**RE: CPUC Data Request #6 for PG&E's Moraga to Oakland X 115 Kilovolt Rebuild Project (A.24-11-005) – Part B Response**

**CPUC Energy Division Data Request 6 Item ALT-1a**  
**Duct Bank Bend Radius Exhibit**  
Moraga-Oakland X 115 kV Rebuild Project  
Pacific Gas and Electric Company

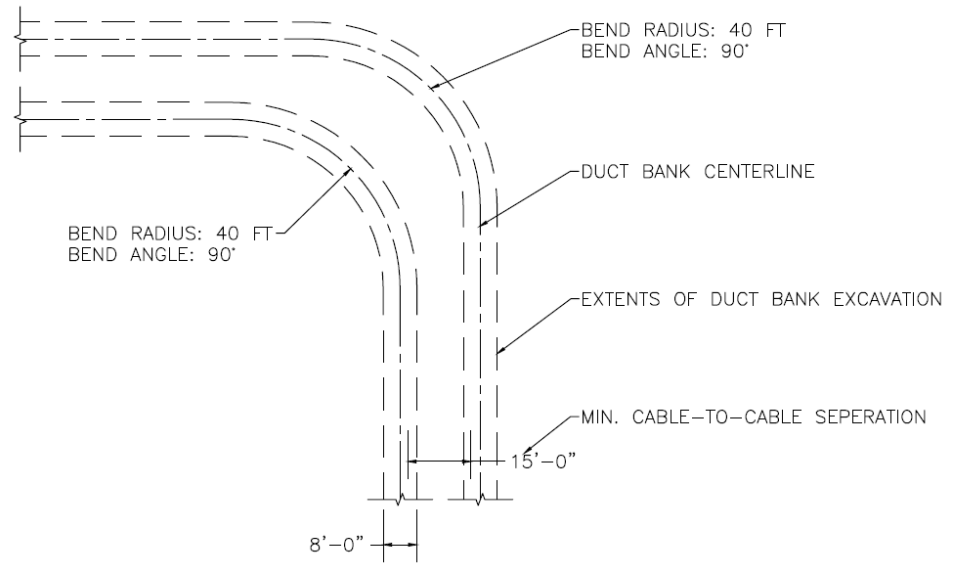
- a. Please define the maximum bending angle for underground conduit or duct banks that could be constructed where all 4 circuits are installed underground in one road, as well as for 2 circuits.

- b. Please define the maximum bending angle for underground conduit or duct banks that could be constructed where only 2 circuits are installed underground in one road.

The maximum bending angle value of a duct bank can change depending on the radius of the bend in the road. Smaller bend radii would allow smaller bend angles and larger bend radii would allow larger bend angles. Therefore, the maximum bending angle is not a reliable value to consider when determining whether one or more duct banks can be installed in one road. Numerous engineering design criteria in addition to a single bend radius are required for a qualified, professional engineer to design an underground double-circuit duct bank. As such, the measurement unit of the bending radius – which is generally assumed to be approximately 40 feet for this project's cable type and double-circuit duct bank configuration (refer to Attachment 1, Duct Bank Bend Radius Exhibit) – is not useful on its own. Also, this bend radius of approximately 40 feet is reasonably feasible only when considered in the horizontal plane. Road geometry (including slope and grade) must be considered as well during design. Road geometry may not accommodate adequate lateral and longitudinal space for a double-circuit duct bank or its separation from an adjacent duct bank to maintain the required ampacity. The distance between the outside duct bank to the inside duct bank would need to maintain a minimum of 15 feet of separation.

Additionally, curvature in a duct bank is limited by cable installation criteria. Pulling tension in the cable increases exponentially through curves and sidewall pressure (a function of pulling tension) with inverse proportionality to curve radii. When a cable is pulled through a conduit, the cable brushes against the sidewall of the conduit as it is pulled into place. When the conduit is not straight, the cable will push against the sidewall as it moves around a bend. Tighter bends create more sidewall pressure. It becomes increasingly difficult to pull the cable with the collective sidewall pressure resulting from the cumulative horizontal curvature (series of bends in the road).

The cumulative horizontal curvature between power line vaults determines the distance between adjacent vaults. Assuming the calculations allow, a cable might be able to be pulled through a single hairpin turn but the cable may not be able to be pulled through the next turn. The pulling calculations look at the entire run of the cable between vaults and not just individual turns. The more bends in the duct bank, the closer together the vaults need to be. Instead of the typical spacing of 1,000 to 1,200 feet, the vaults may need to be closer together to splice the line more frequently. However, lines with a greater number of splices, which would occur with more closely spaced vaults, often are less reliable during operation.

Refer to the response to ALT-1a and Attachment 1, Duct Bank Bend Radius Exhibit. The discussion on the maximum bending angle for underground conduit or duct banks that could be constructed where only 2 circuits (in a single double-circuit duct bank) are installed underground in one road does not differ from the maximum bending angle for two double-circuit duct banks installed in one road. However, in this scenario, road geometry only would need to accommodate adequate lateral and longitudinal space for one double-circuit duct bank instead of considering its separation from an adjacent duct bank to maintain the required ampacity.
